Project #21-002
Logan Gateway Retail Development
Located at 701 South Main Street

Project Name: Logan Gateway Retail Development
Proponent/Owner: Scott Hamblin / Logan Gateway Business LLC, GSK Prop. LLC
Project Address: 701 South Main Street
Request: Design Review Permit
Current Zoning: Commercial (COM)
Date of Hearing: January 14, 2021
Type of Action: Quasi-Judicial
Submitted By: Russ Holley, Senior Planner

Figure 2 shows the proposed site plan

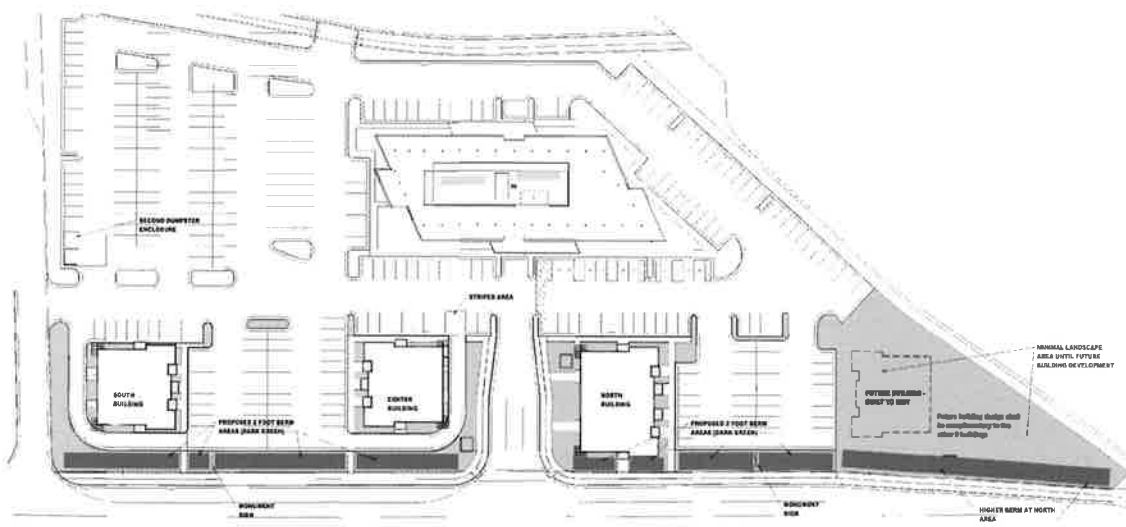
To prioritize architecture and curb-appeal, the LDC 17.10.080 typically requires parking areas to be in subordinate side or rear positions to the buildings in the COM zone. The proposed project shows parking lots positioned to the side and rear of the three buildings with berms and landscaping to further subordinate surface parking area and to help muffle Main Street noises. The LDC 17.10.080 requires a 50% building frontage, a ratio of building mass to property width, in the COM zone. The three pad-site properties total approximately 530 feet in width. At approximately 210 feet of total building width and accounting for the 65' driveway entrance, the building frontage totals approximately 45%. As conditioned with building frontage compliance at 50%, the project meets the requirements of the LDC.

The LDC 17.31.040 requires one (1) parking stall per every 75 SF of dining area for fast food restaurants and (1) parking stall for every 250 SF of total retail area. The proposed building(s), depending on the breakdown of retail/restaurant use, would require between 16-20 parking stalls for each smaller building and between 21-24 for the larger building. When a business license is submitted, the exact breakdown of space dedicated to either retail or dining rooms will be calculated. Using the high end of the above ranges (retail vs restaurant at 30% dining area), the LDC would require 64 parking stalls. The project shows 67 parking stalls for the three pad-site buildings.

The proposal includes two drive thru lanes. The LDC requires space for 8 cars to stack in the drive thru lane before the order box of a restaurant. The proposed drive thru lanes contain space to stack approximately 8 vehicles from the entrance point to the exit point. Assuming the order box isn't placed right at the exit point, the proposed drive thru lanes do not contain enough room for 8 cars to stack before the order box. The order box position has not been identified at this time and every restaurant has slightly different drive-thru specifications. The surrounding site provides additional areas to stack drive-thru cars but could potentially create circulation conflicts and parking stall access issues. Given the size of the properties and pad-site buildings, if addition drive-thru lanes were created it would result in the loss of parking stalls and pedestrian access to storefronts. Bike racks are required as per the LDC for restaurant and retail land uses. As conditioned with sufficient drive thru lane stacking, the project meets the parking requirements in the LDC.

1. All standard conditions of approval will be recorded with the Design Review and are available in the Community Development Department.
2. The project shall provide 64 parking stalls for all three buildings. Individual businesses will be reviewed and approved for parking stall code compliance at the time of business license submittal. Bike racks shall be installed for bicycle parking.

3. Drive thru lanes shall contain at least 8 stacking positions measured from the order box. A flow pattern design shall be included in the building permit package detailing drive-thru lane flow and circulation.

4. The project shall provide 50% building frontage along Main Street.
5. Enhanced landscaping that matches "Type B" in LDC 17.32.070 shall be placed in the areas between Main Street and the parking lots to help screen those areas.
